Yamada Bulletin

Changes in the Pilot Valve Assembly of NDP-40/NDP-50

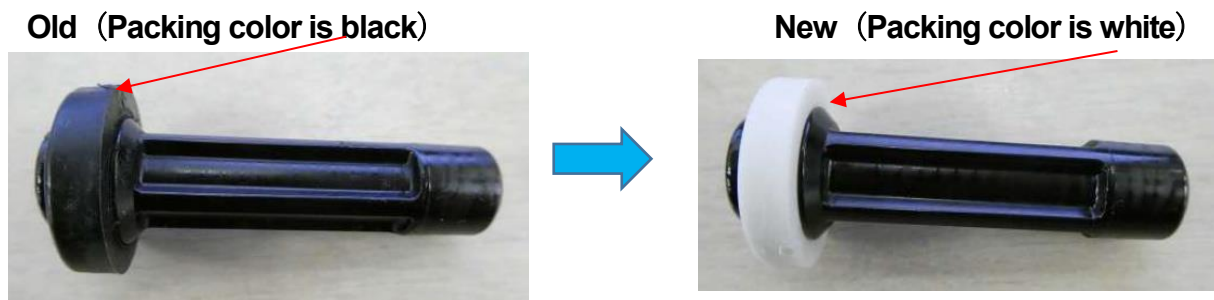
(1) Packing Material:

The grade of TPEE, which is the raw material, has been changed in order to improve the oil resistance. Accordingly, the color of the packing has changed from black to white, as the following pictures say.

Cross section of packing

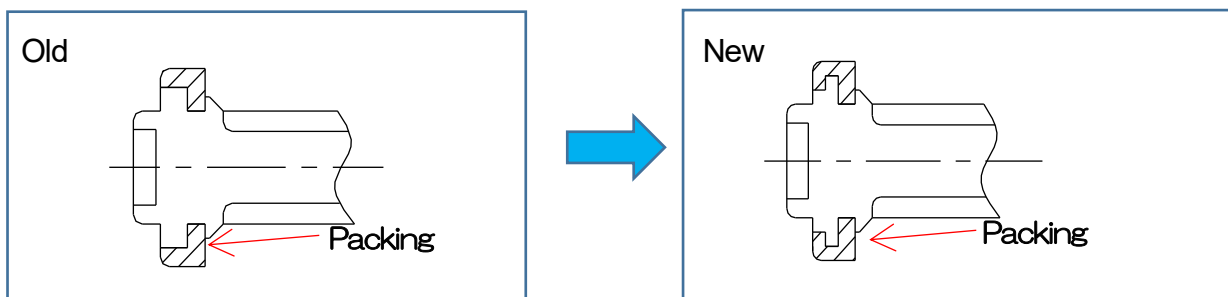
(2) Shape of Packing:

The shape of the packing has been changed as the following drawings, so that the packing will not be easily removed.
